**ADDENDUM # 1**

<b>Project</b>	TA Blakelock High School Renovations	<b>Project No.</b>	2215-C
<b>Location</b>	1160 Rebecca Street, Oakville, ON	<b>Date of Issue</b>	2025 04 24
<b>Owner</b>	Halton District School Board	<b>File</b>	2215/7.1.3

This Addendum forms part of the Contract Documents and amends the original Drawings and Specifications, dated 2025 04 17, and all preceding Addenda, as noted below.

**A1-3 DRAWING A100 KEY PLAN, FLOOR PLANS - ELEVATORS - NEW**

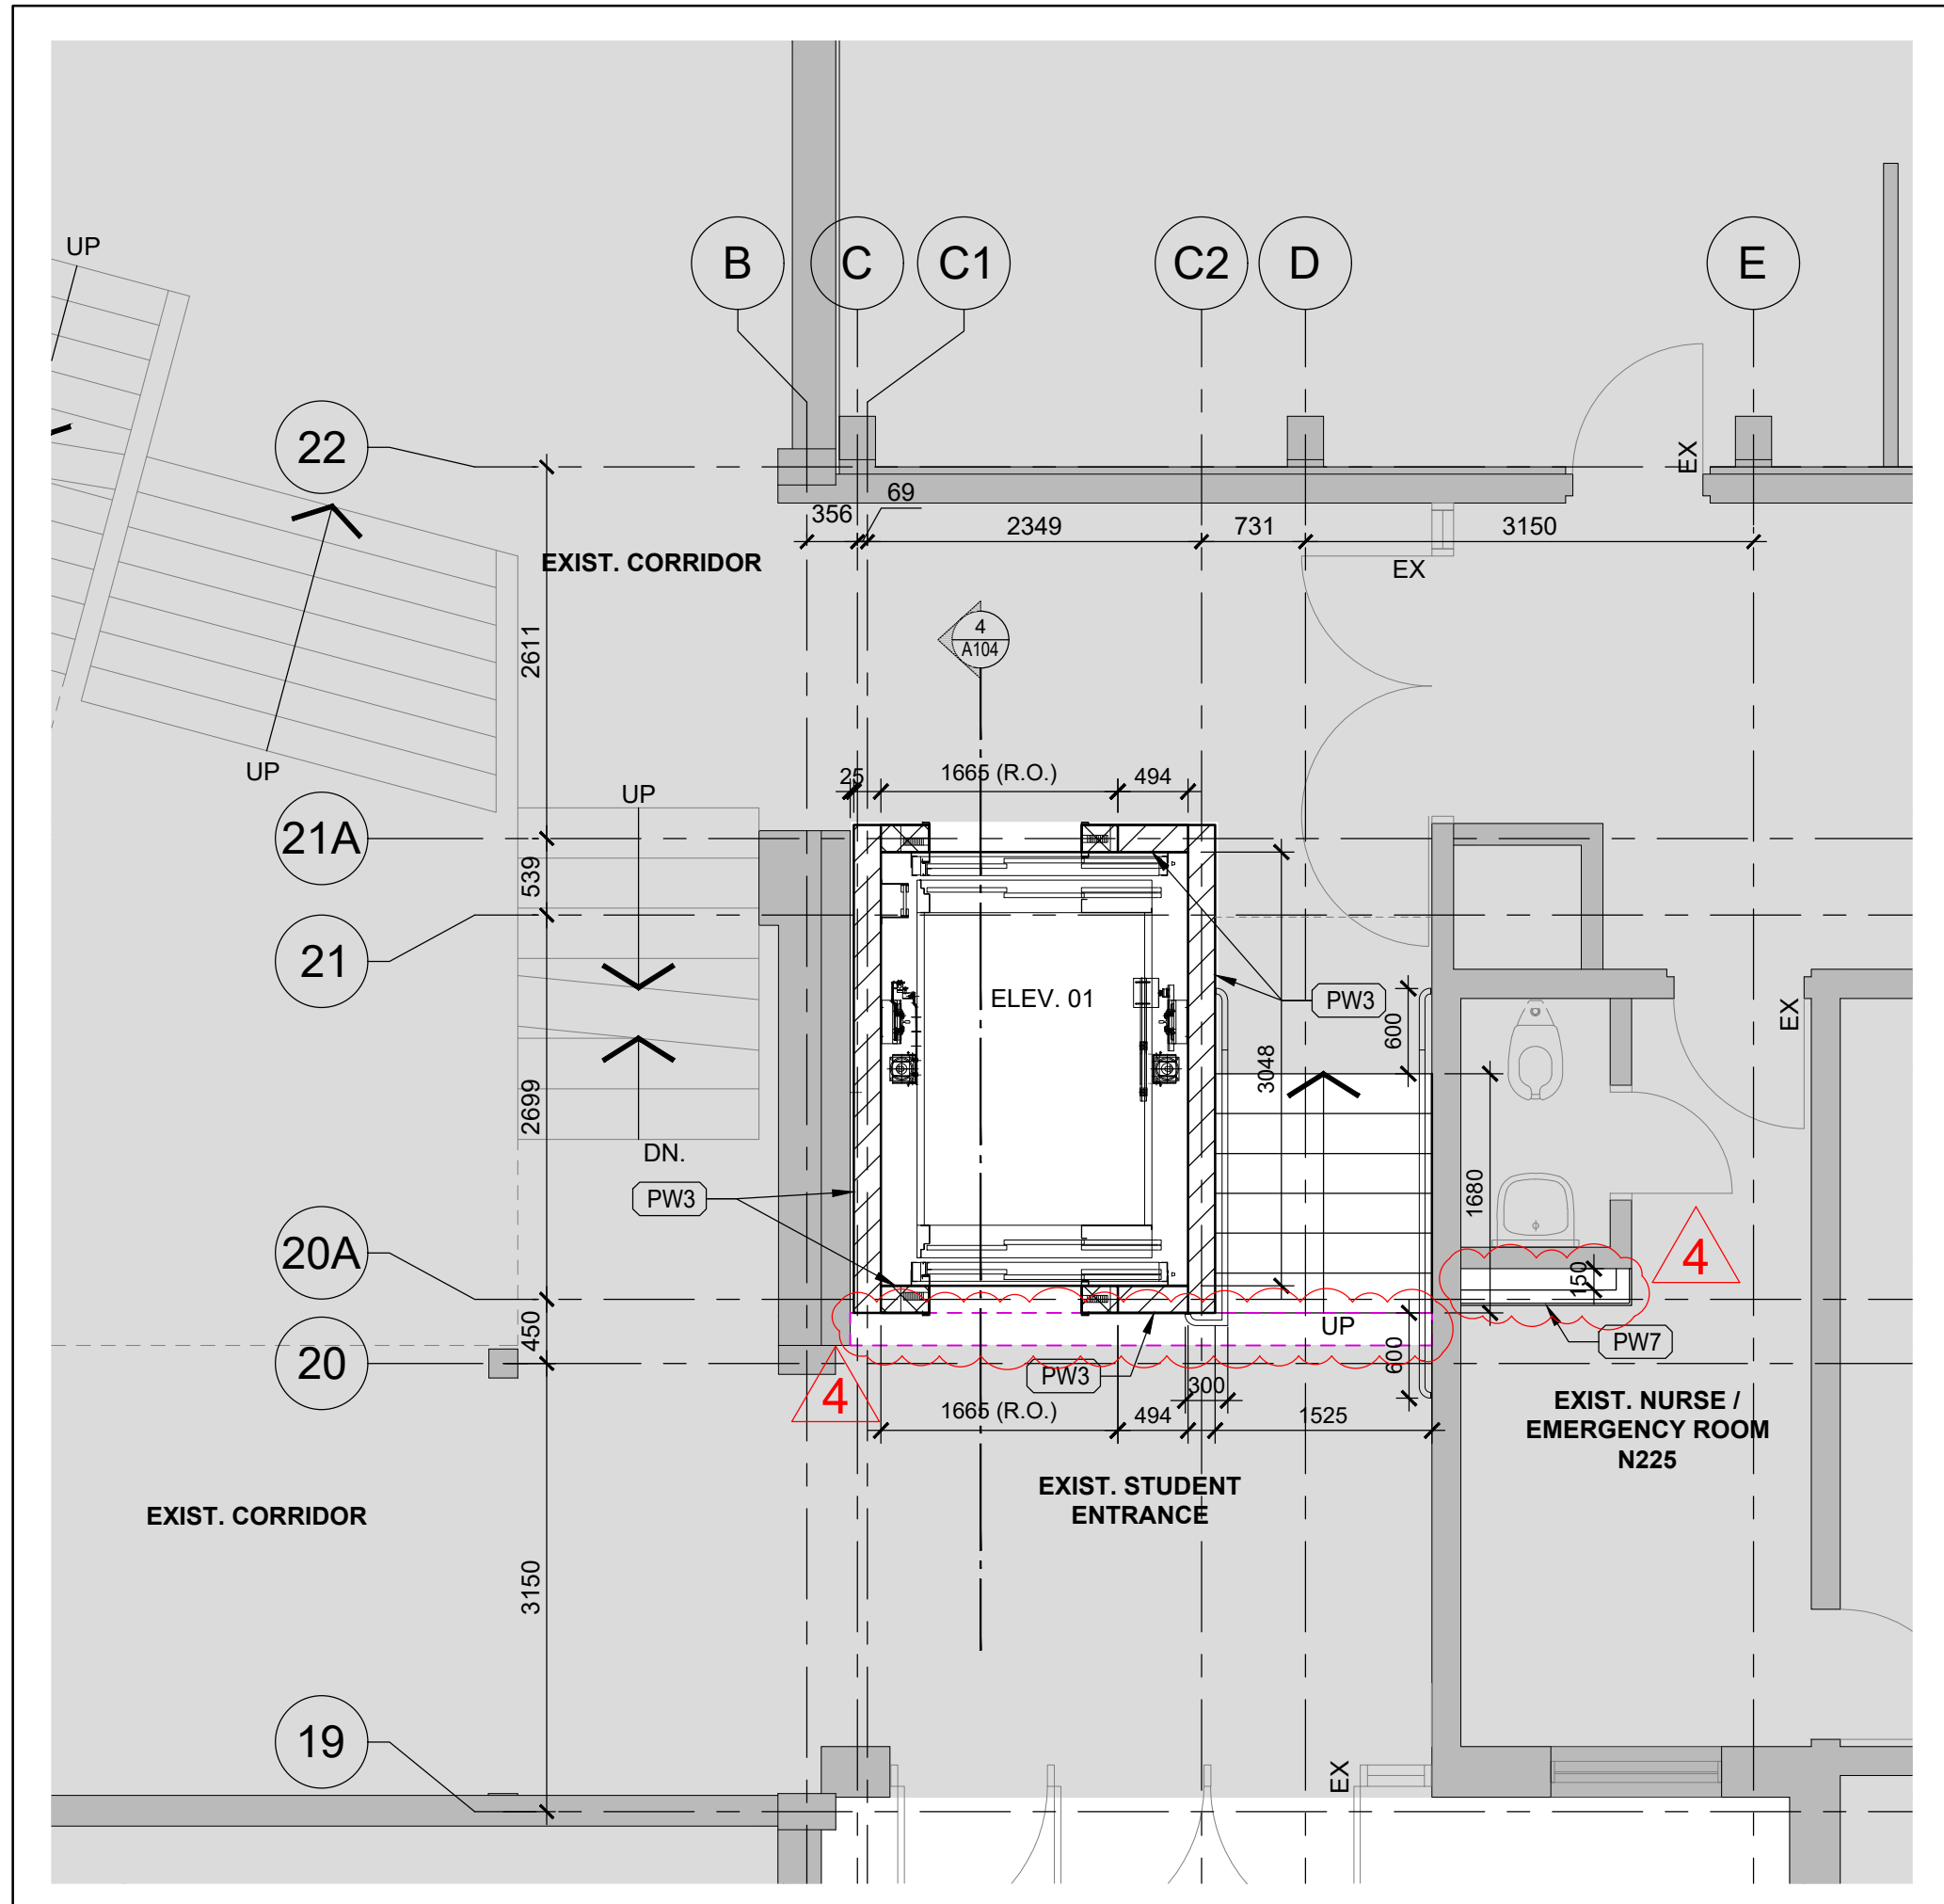
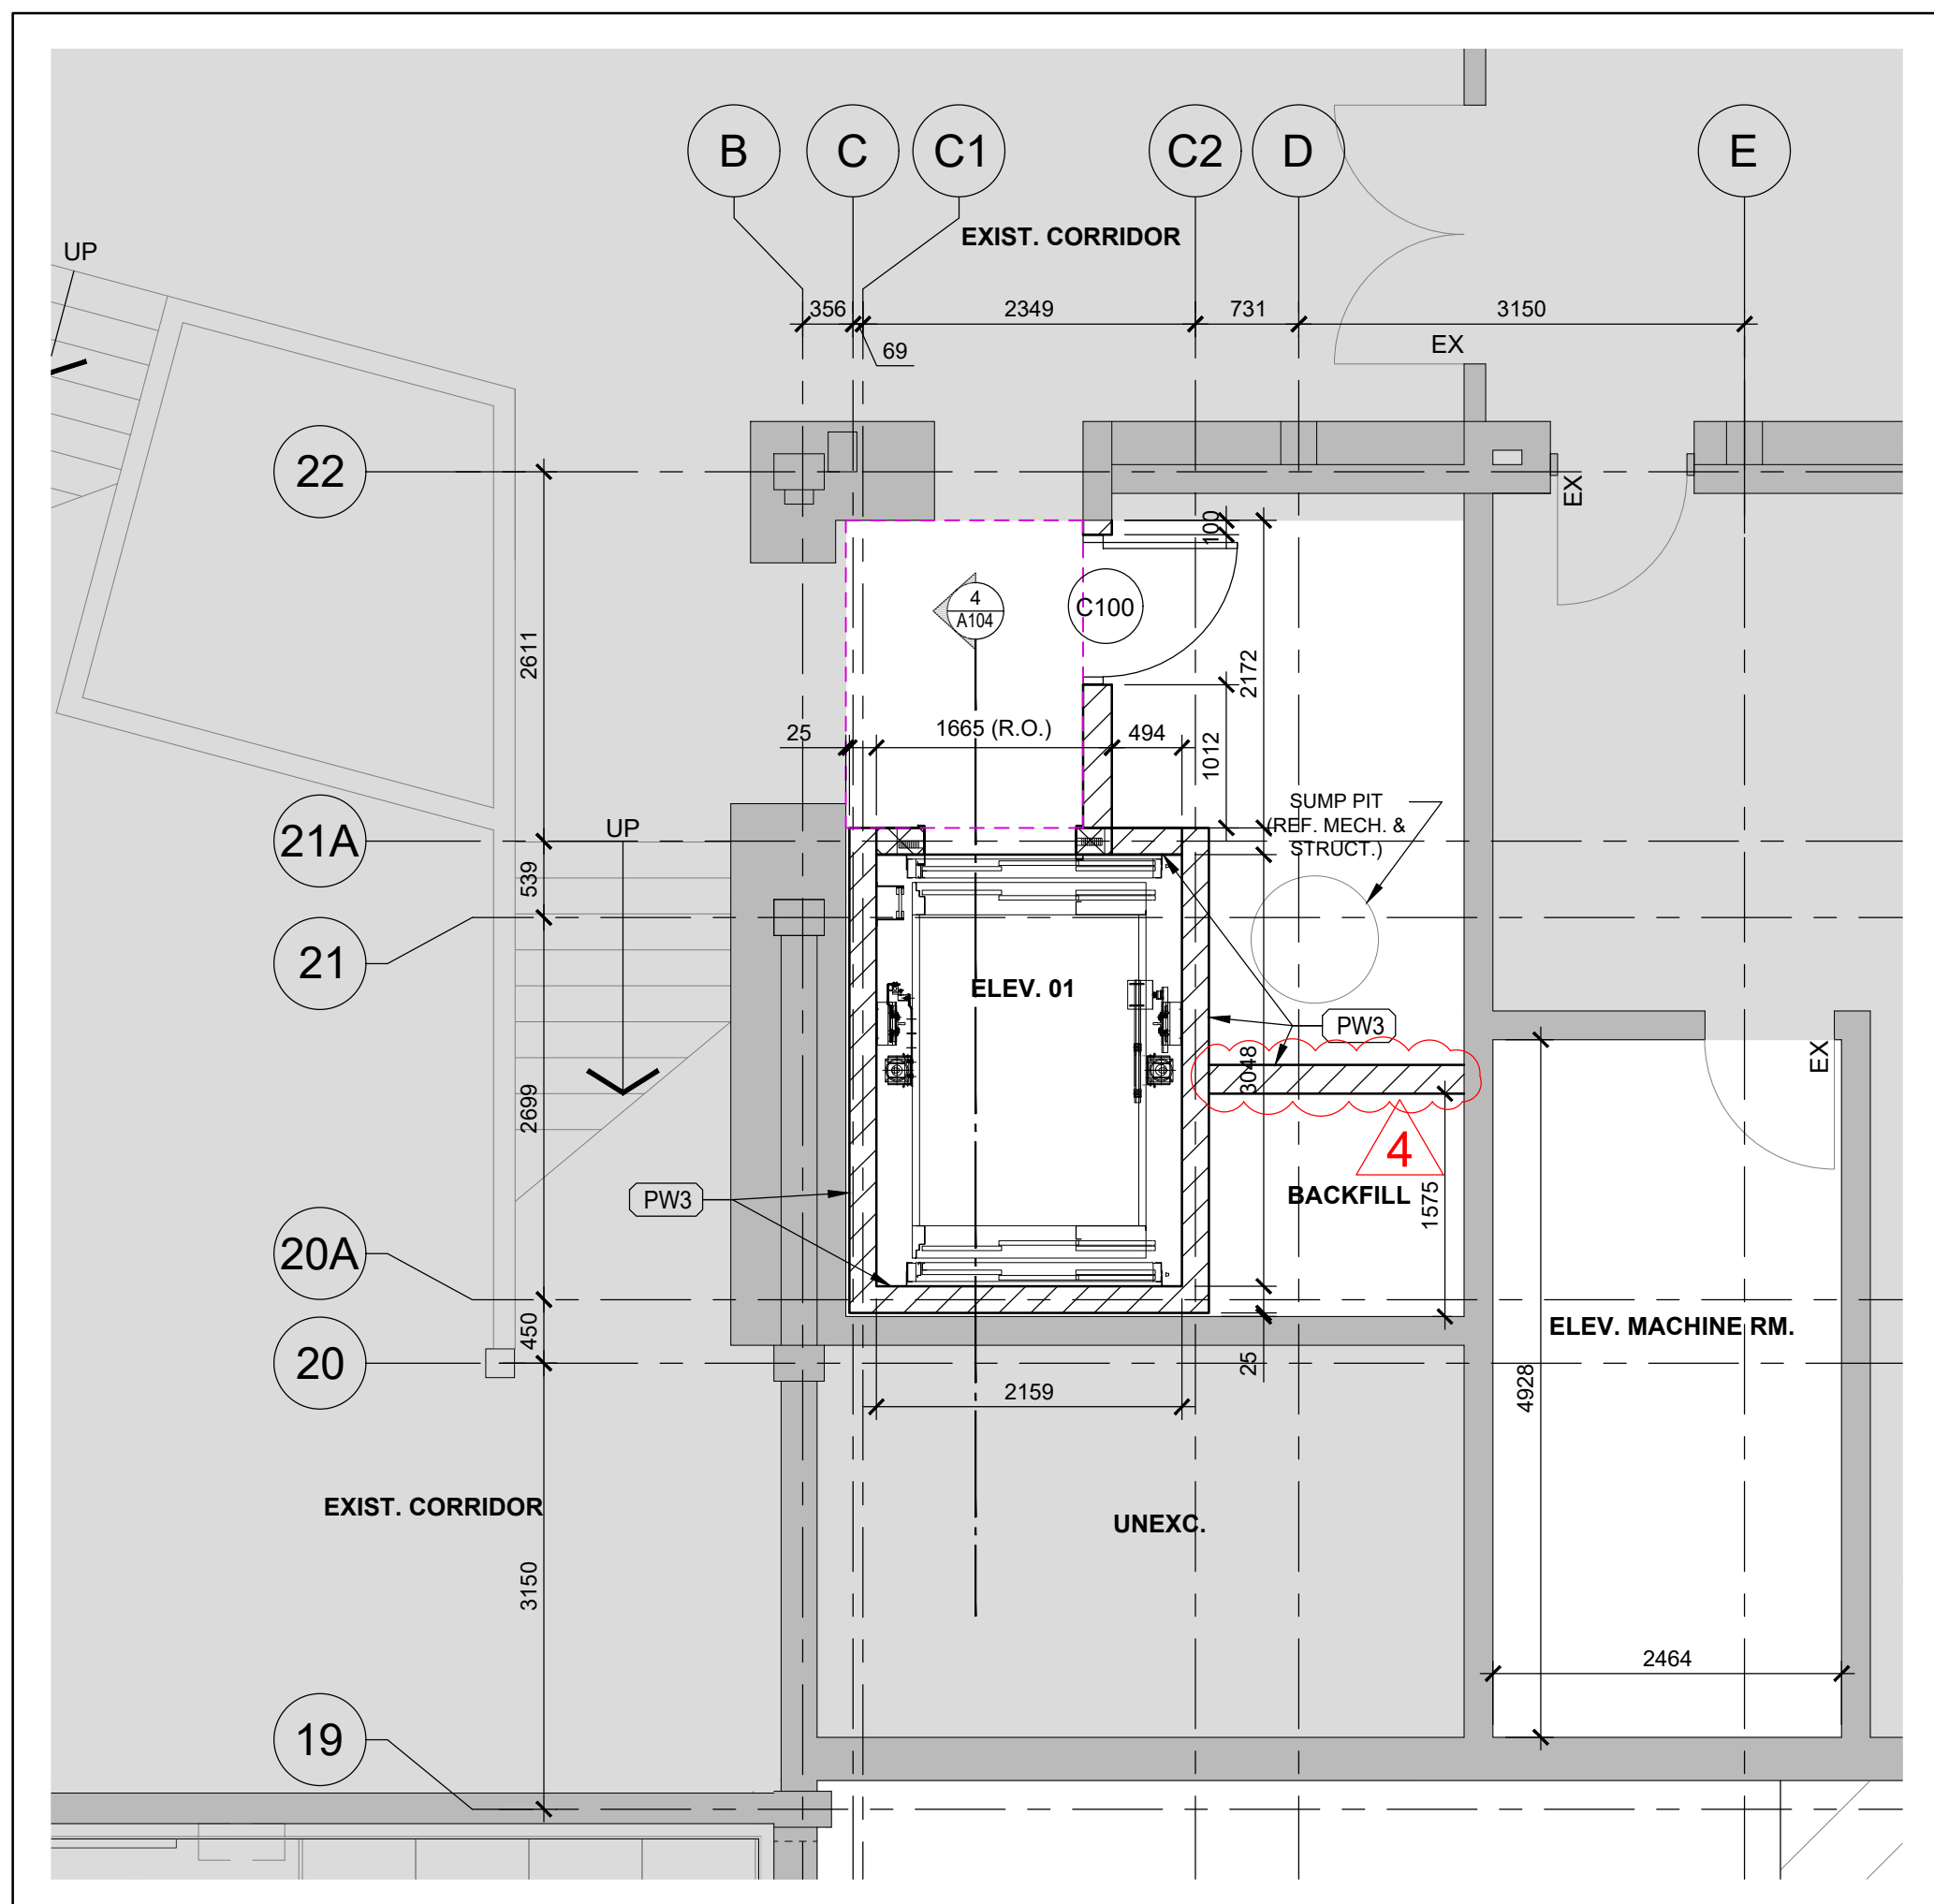
- .1 Replace drawing with the attached Revision No. 4.
- .2 Drawing reissued to clarify scope and include new walls/chase based on coordination with Mechanical and Electrical drawings.
